**Re: Notice of Preparation and Initial Study for the Nevada Cement Company LLC
Stockton Terminal Modernization Project**

Re: 2024100490 Nevada Cement Company LLC Stockton Terminal Modernization Project, San Joaquin County

Re: Notice of Preparation of a Draft Environmental Impact Report for the proposed Nevada Cement Company LLC Stockton Terminal Modernization Project

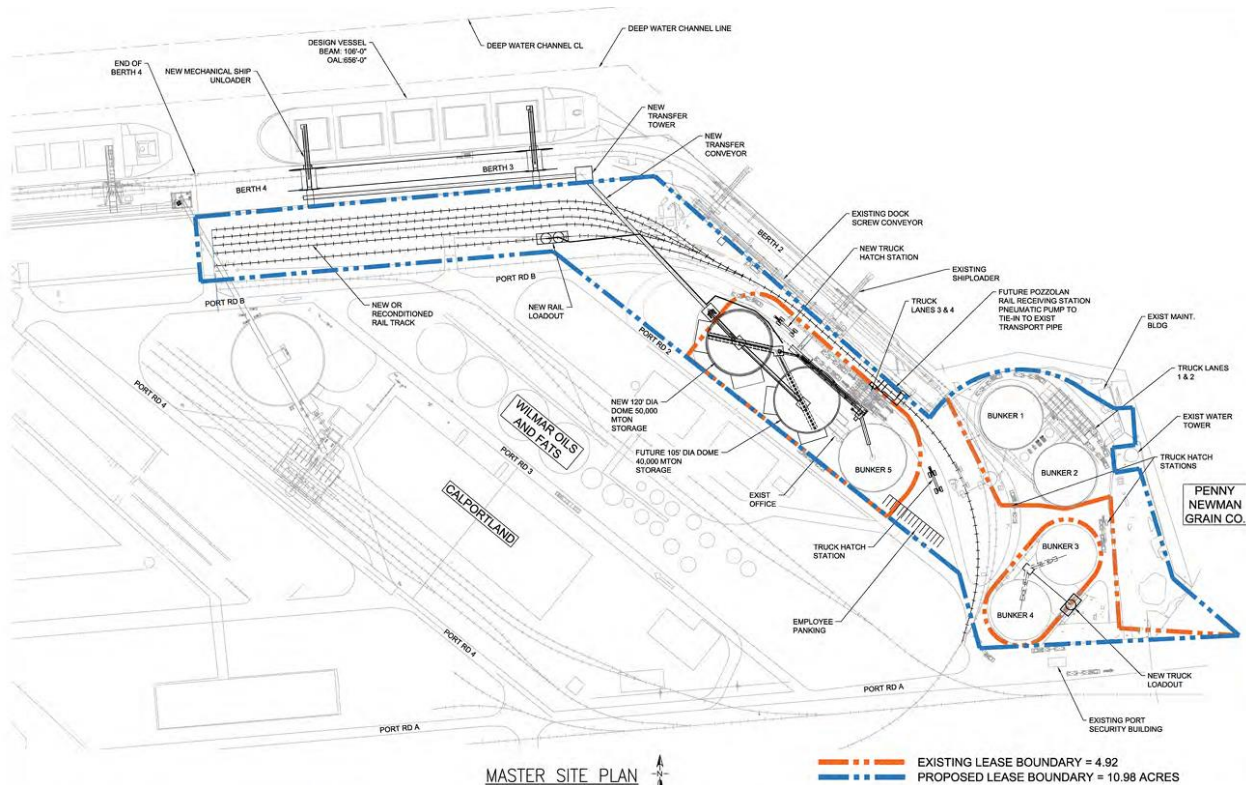
Below is a map and diagram showing the proposed project site and berths 2, 3, and 4.

Nevada Cement seeks to modify its lease with the Port to increase the terminal's leasehold area from 4.92 to 10.98 acres. The 4.92-acre existing leasehold area is reflective of only the areas under existing storage structures. However, current terminal operations occur within, between, and around the storage structures and *actually encompass an area of 8.18 acres*, including the area around the Berths 2 and 3 unloading operations, rail storage and loading, and truck lanes serving the various outbound operations by truck. Accordingly, the lease modification would reflect the *actual terminal operation area* as well as the proposed expanded operation area.

The NOP/IS describes terminal improvements including the rehabilitation of Berth 3/4 to support a new ship unloader to service longer and wider vessels, removing derelict equipment and dilapidated structures from the Berth 3/4 operational area, installing unloading equipment on the combined Berth 3/4, constructing tracks to increase rail loading capacity, and removing and replacing an existing terminal storage bunker with a higher capacity storage dome. The M/V Golden Arrow, a floating silo ship that has been used for cement operations at Berth 3/4 since 2003, would be discontinued from use and relocated outside of the Port to free up Berth 3/4 for increased throughput of cementitious material. The DEIR should include a description of the condition of this

ship and the disposition when moved outside of the Port. These terminal improvements will support higher volumes of cementitious product handling and additional ship, truck, and rail calls as compared to current operations. The upgraded terminal would be designed to accommodate either ship or barge operations.
